REHABILITATION STRUCTURE SURVEY REPORT

Design Project ID 1021-03-10	Construction Project ID 1021-03-80	Highway (Project Name) STH 93			
Final Plan Due Date February 1, 2020	Preliminary Plan Due Date May 1, 2019	☒ Town ☐ Village ☐ City Washington			
PS&E Date May 1, 2020	Letting Date July 9, 2024	County Eau Claire			
Structure Number B-18-0119		Section 3	Town 26N	Range 9W	
Station 669+77	Latitude: 44.765795 Longitude: -91.458931	☐ YES ☐ NO Structure Located on National Highway System			
For Survey and CADD Files Horizontal Coordinate System: Eau Claire County Vertical Datum: NAVD88		Traffic Forecast Data			
		Design Year	Average Daily Traffic (ADT)	Roadway Design Speed	Functional Class
Feature On STH 93 NB		Feature On 2042	25400	45 MPH	Principal Arterial
Feature Under IH 94		Feature Under 2042	38800	70 MPH	Principal Arterial
Region Contact: Stacie Lambelle (Area Code) Telephone Number(s): 715-577-2967 Email: stacie.lambele@dot.wi.gov		Consultant Contact: Tara Krista (Area Code) Telephone Number(s): 715-720-6291 Email: tkrista@sehinc.com

STATE OF WISCONSIN DEPARTMENT OF TRANSPORTATION DIVISION OF HIGHWAYS			
STRUCTURE B-18-119			
S.T.H. 93 (N.B.LANES) OVER INTERSTATE 94			
COUNTY	E

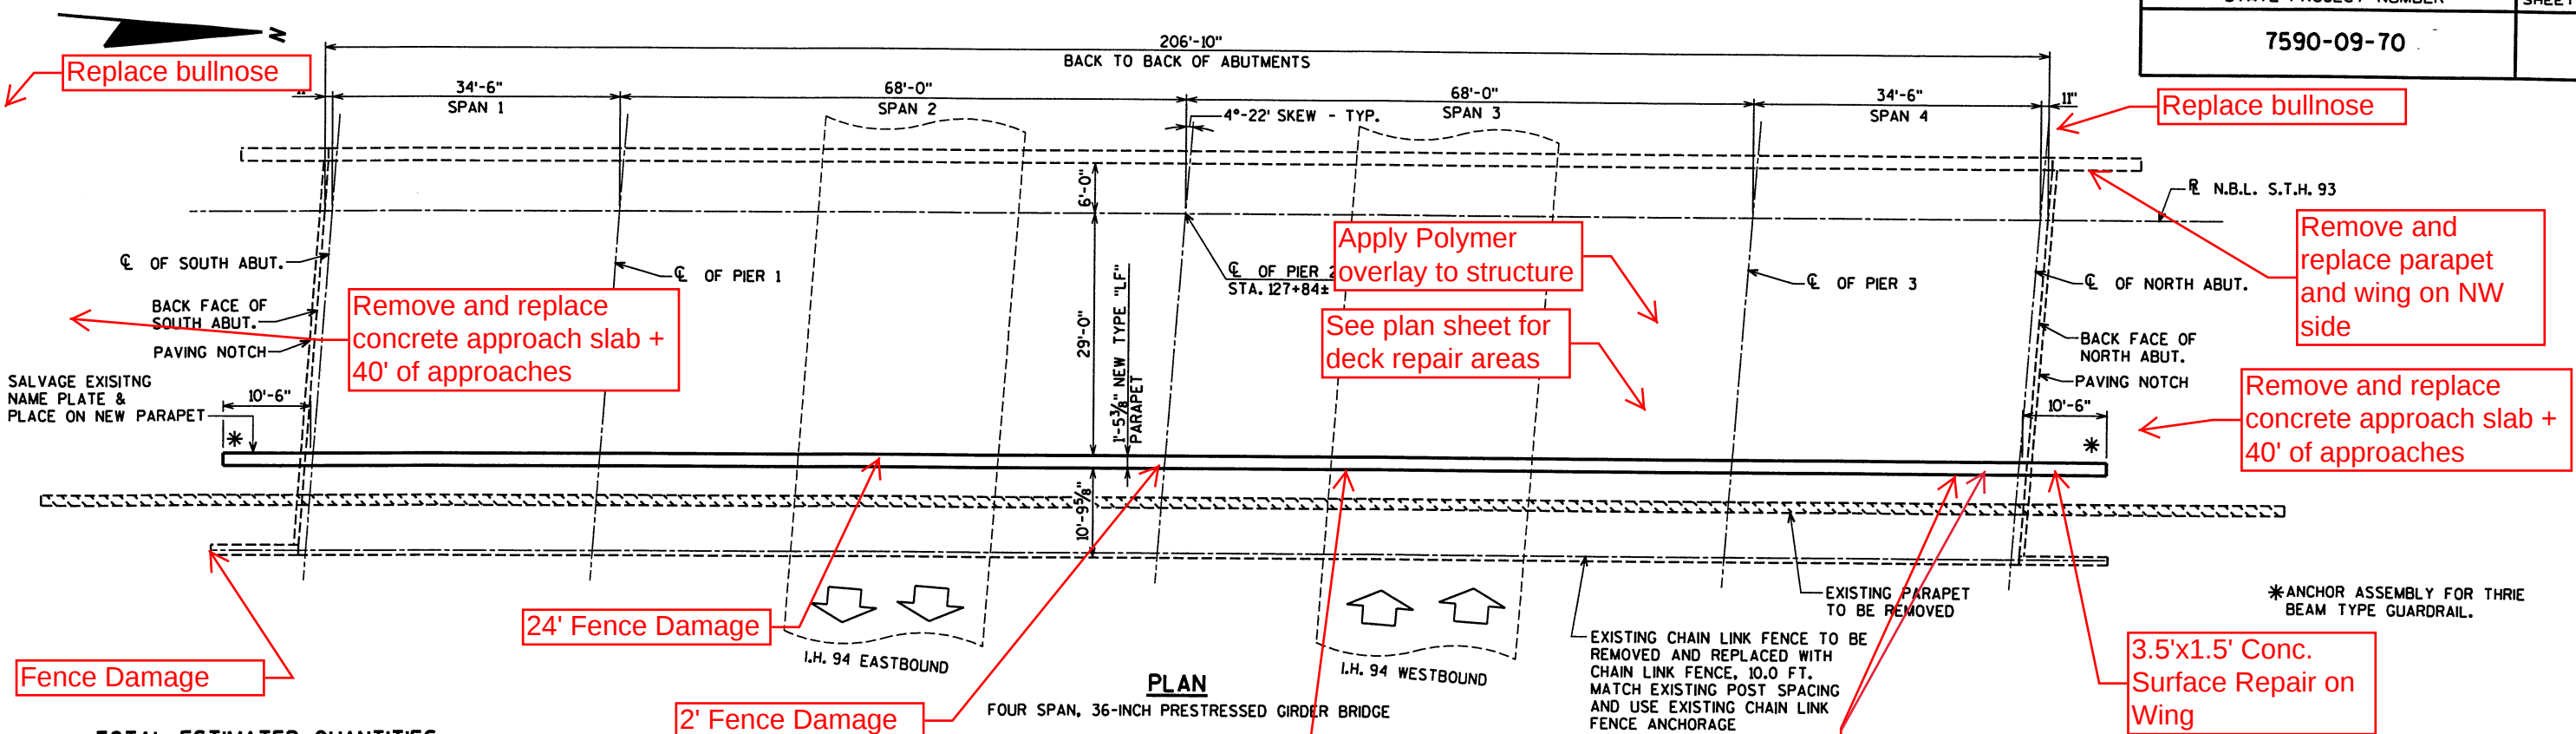
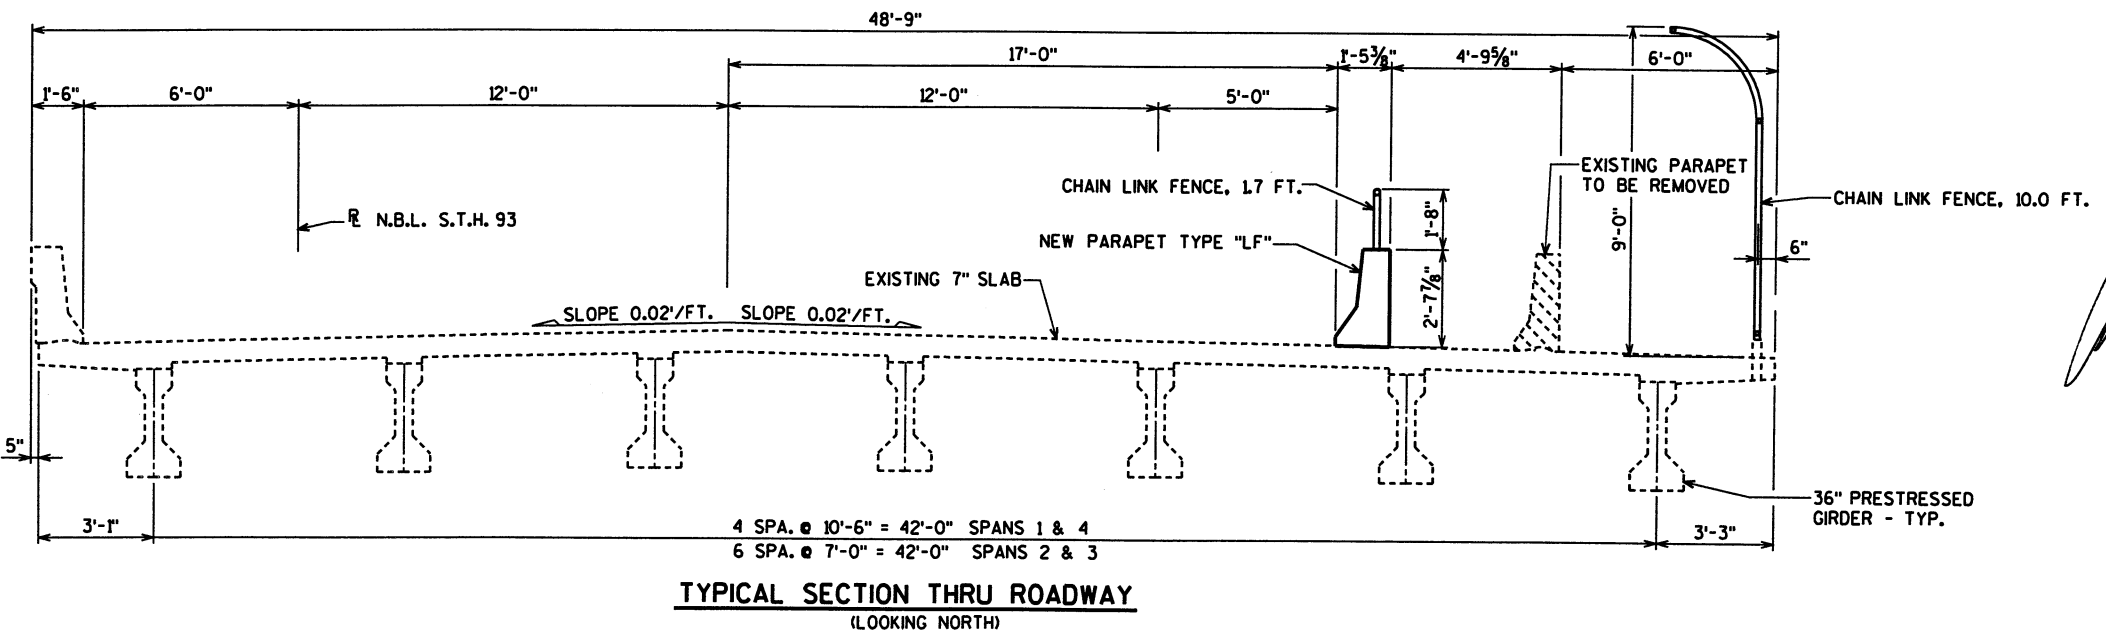
Fence Damage

24' Fence Damage

Replace bullnose

Remove and replace parapet and wing on NW side

Remove and replace concrete approach slab + 40' of approaches

3.5'x1.5' Conc. Surface Repair on Wing

2-1'x1' Conc. Surface Repair on Parapet

No.	Date	Revision	By
1	1981	By R.J.G.	Checked MOK
STATE OF WISCONSIN DEPARTMENT OF TRANSPORTATION DIVISION OF HIGHWAYS			
STRUCTURE B-18-119			
NORTH ABUTMENT			SHEET 5 OF 15
			X82066

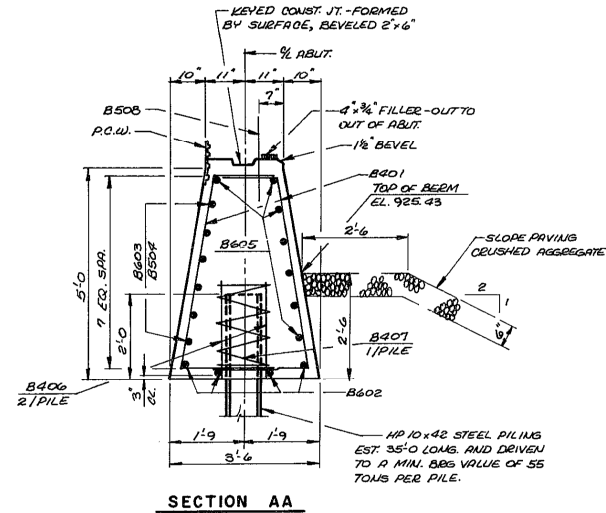
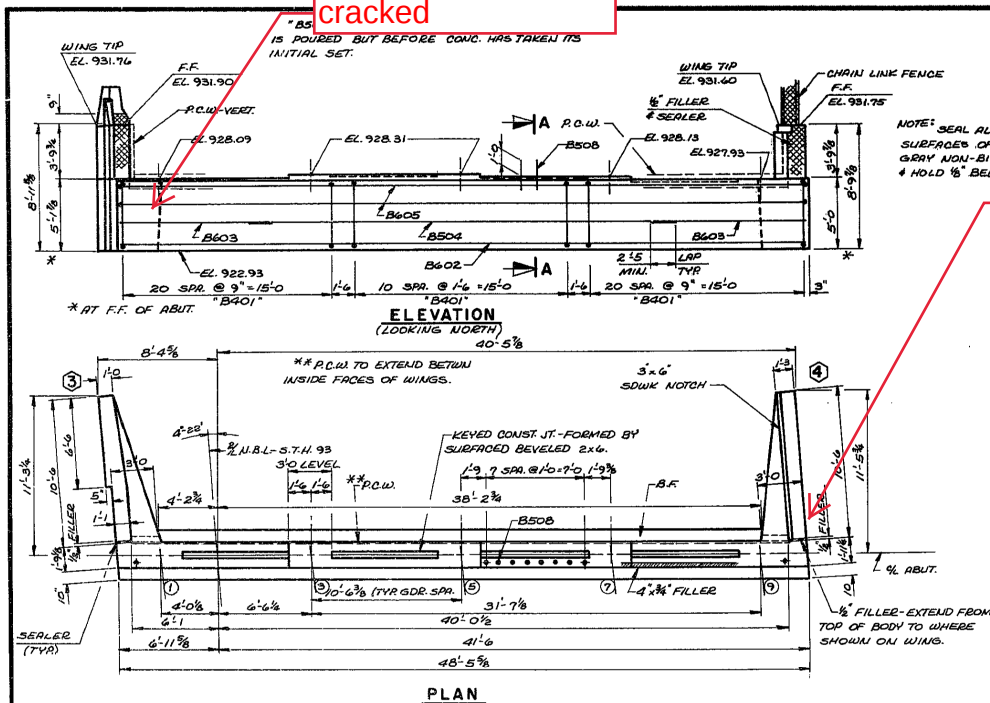
Abutment Backwall
cracked

STATE OF WISCONSIN
DEPARTMENT OF TRANSPORTATION
DIVISION OF HIGHWAYS
STRUCTURE B-18-119
PIER 3
SHEET 9 OF 15
X82066

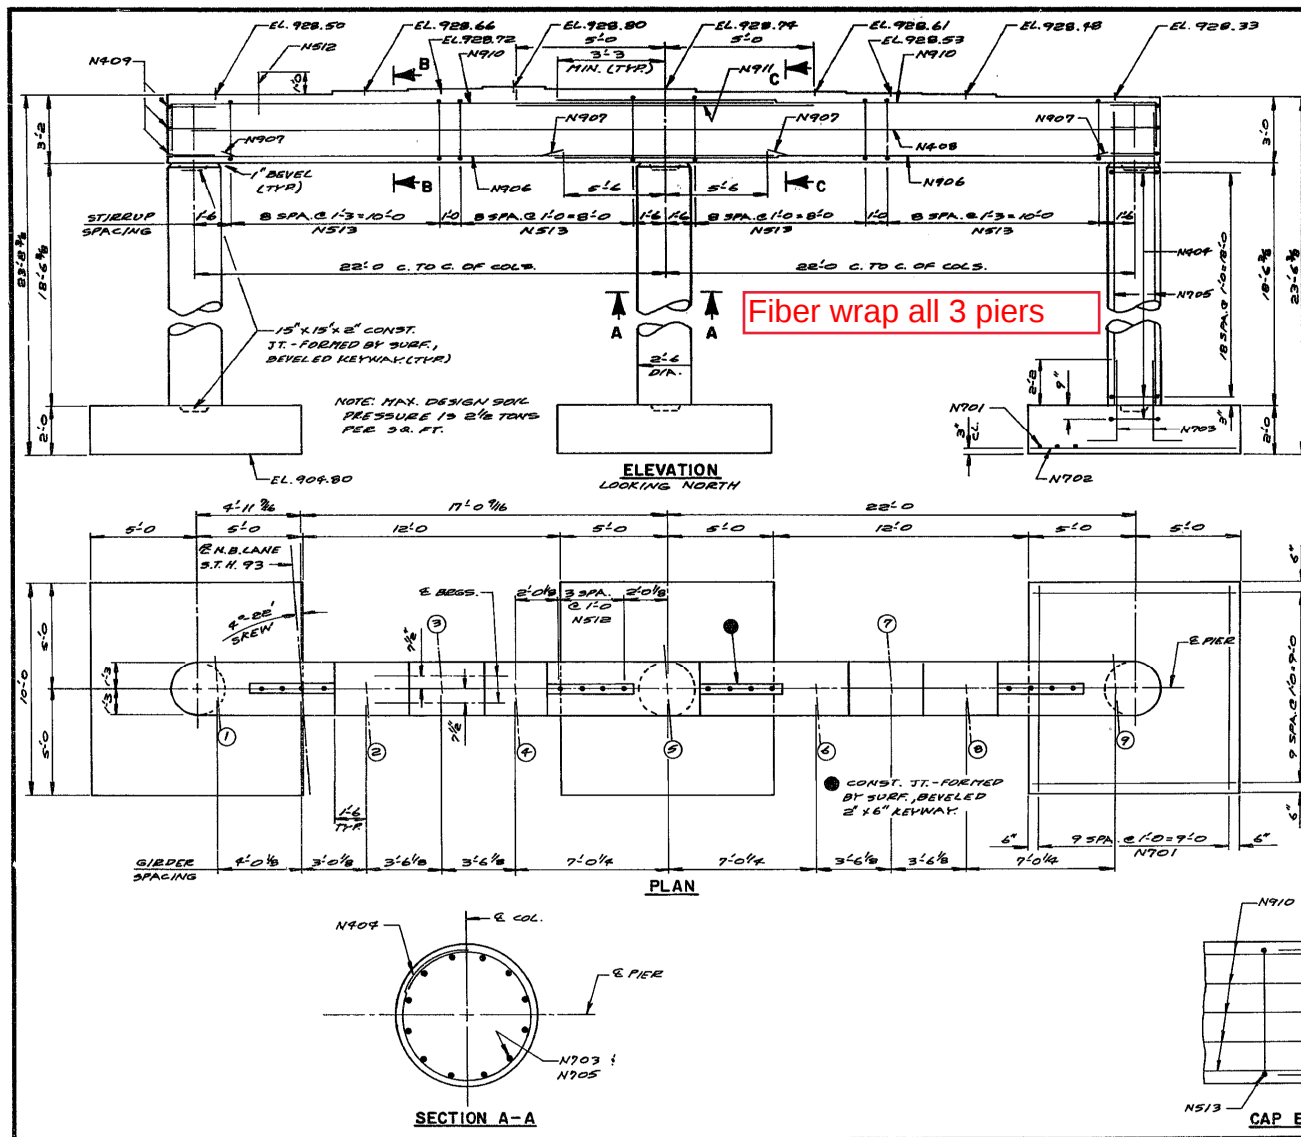
Fiber wrap all 3 piers
